**HUGHES
SERVICE INFORMATION
NOTICE**

NOTICE NO. HN-93

SUBJECT: OPERATIONAL CHECK AND ADJUSTMENT OF AUTOLATCHING
MECHANISMS - PILOT AND CARGO DOORS

MODELS AFFECTED: 369H Series Helicopter Serial No. 0201 and subsequent

Figure 1. Door Autolatch Mechanism Positions

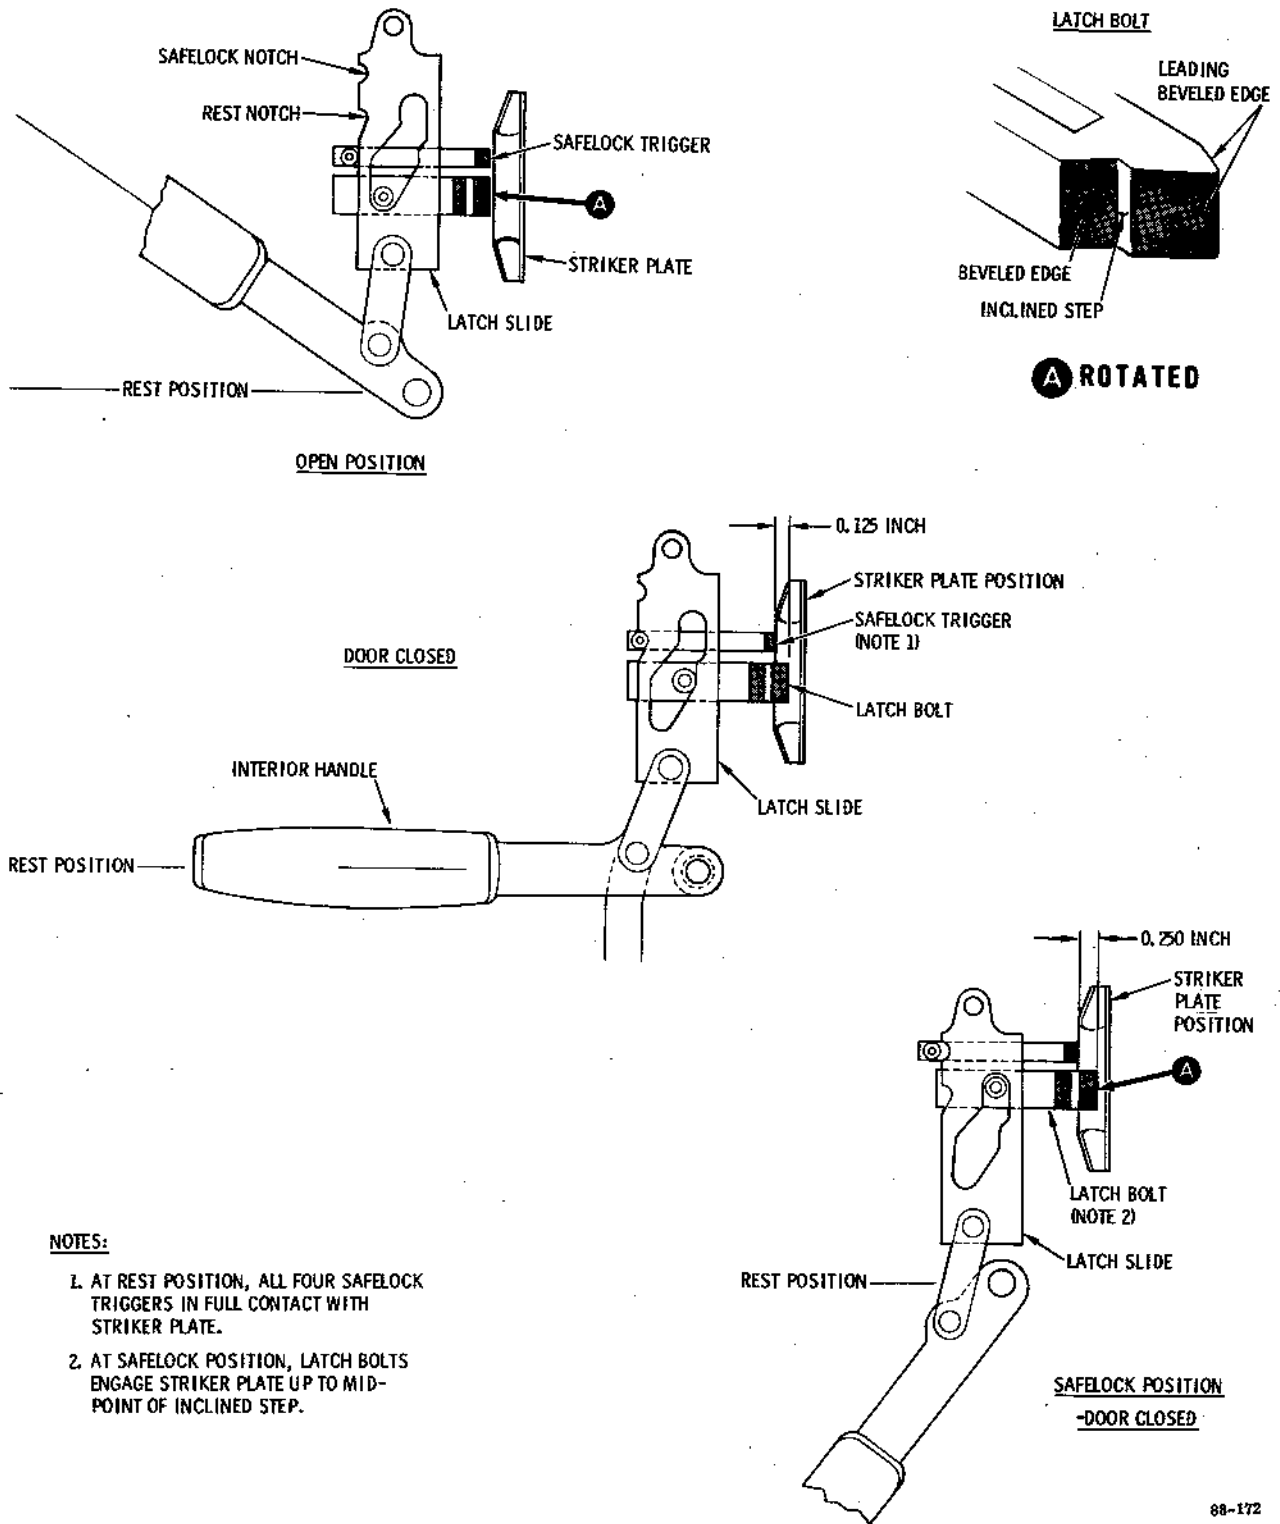
c. Close door while seated in helicopter; interior door handle should be in REST position (see Figure 1).

d. Visually check that all four SAFELOCK triggers are in positive and simultaneous contact with striker plates at all four latch positions.

e. With door closed and interior handle at REST position, visually check that all four latch bolts engage properly with striker plates, as shown.

f. With door closed and interior handle at SAFELOCK position, visually check for positive and simultaneous dead bolt locking at all four door latch positions, as shown.

The beveled leading edge step at end of each latch bolt is the key to proper engagement with the door striker plate. At latch REST position, the full face (approximately 1/8-inch) of the short beveled leading edge step should be in positive contact with the striker plate.

At latch SAFELOCK position, each latch bolt must engage door frame striker plate a minimum of 1/8-inch beyond the beveled leading edge step (at midpoint of inclined step between the two beveled edges). Total throw of each latch bolt into striker should be approximately 1/4-inch at SAFELOCK position.

Figure 2. Door Autolatch Mechanism, Third Latch Position

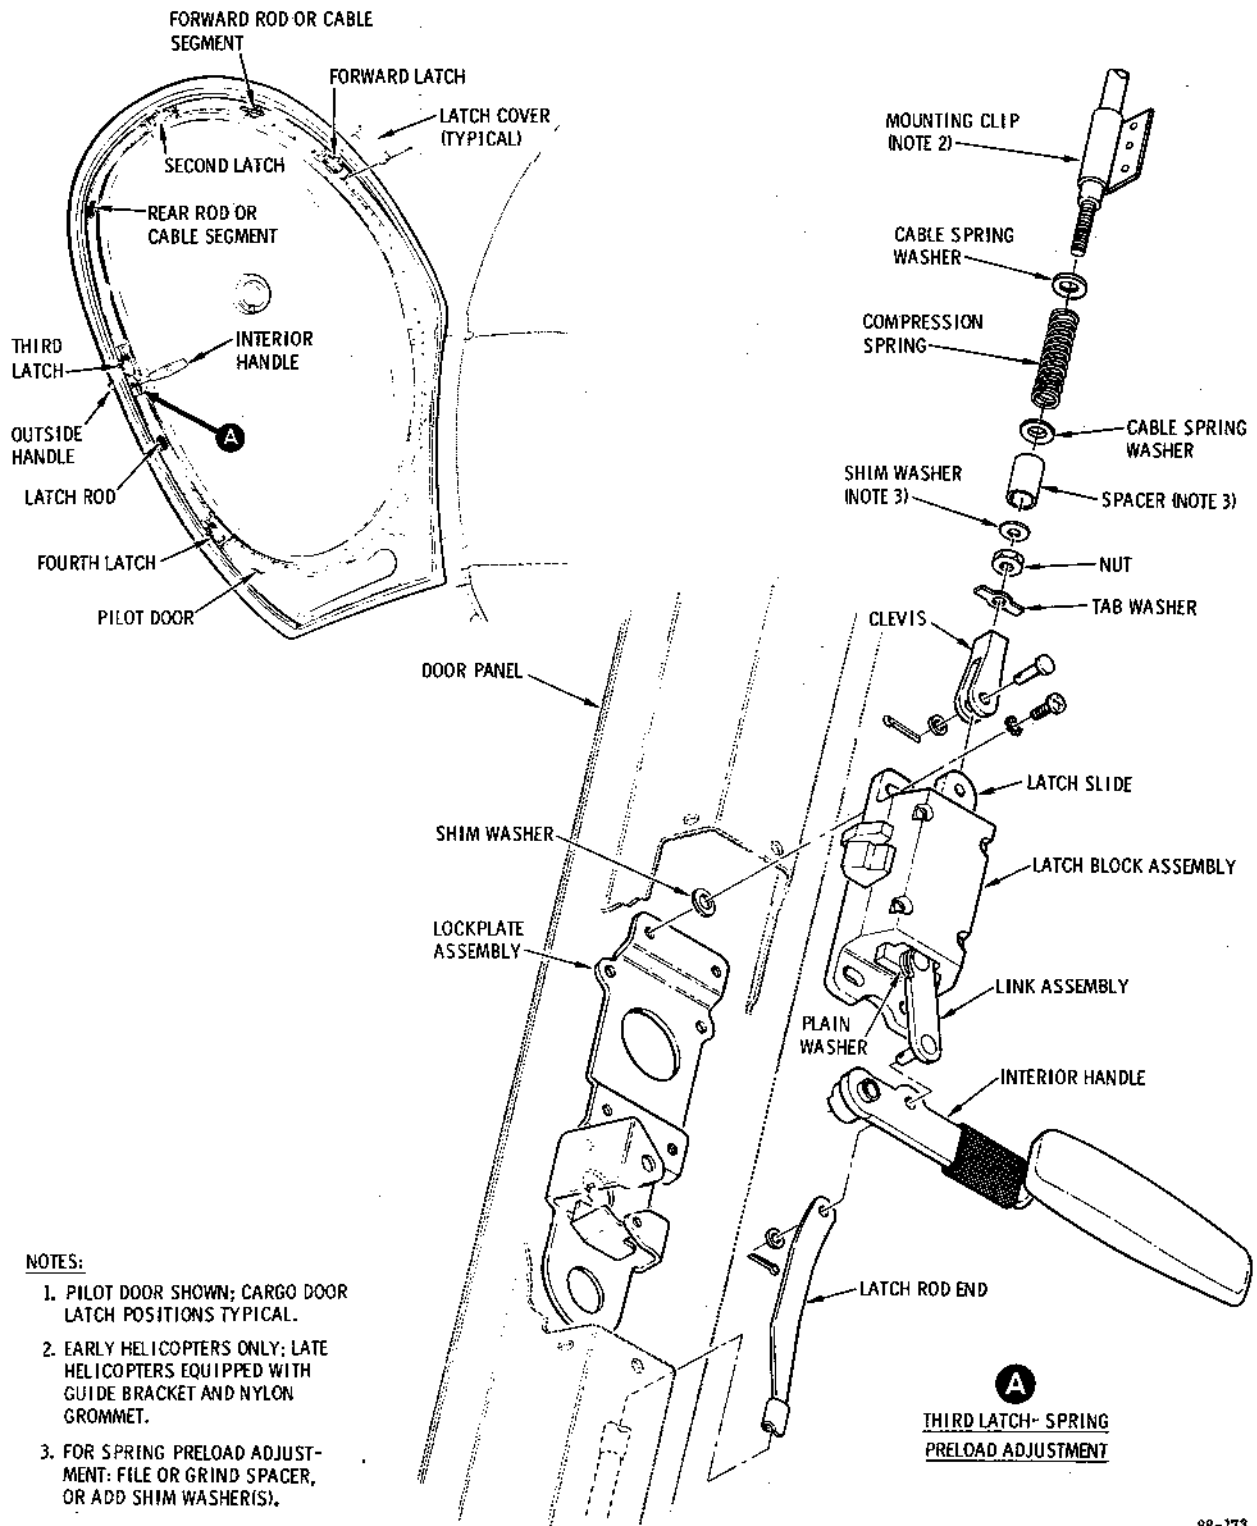
c. With door open and third latch cover removed, adjust preload of latch compression spring as follows: (See Figure 2.)

1. Depress all four safelock triggers and set door handle to SAFELock position.

2. Remove screws and lockwashers securing third latch block to door panel. Note or index location of latch block on mounting plate to facilitate reinstallation.
3. Remove link from interior handle; removal of link at latch slide not required.
4. Note and record number of threads on rod or cable and extending through clevis at top of third latch.
5. Remove clevis from upper end of third latch slide; if installed, remove tab washer and locknut.

If existing handle operation is difficult, remove and file or grind existing NAS43DD3 spacer as required to decrease spring compression. Reinstall spacer.

If existing handle operation lacks firmness, add AN960-10L shim washer(s) as required at existing spacer to increase spring compression.

6. Reinstall locknut and tab washer, as applicable; reinstall clevis at end of rod or cable at position noted in step 4, above. As applicable, tighten locknut and bend tab of washer over clevis.
7. Reinstall third latch at location noted in step 2, above; reinstall rod or cable end clevis to the latch slide, and link to interior door handle.
8. Adjust rod or cable length, per step II a above.
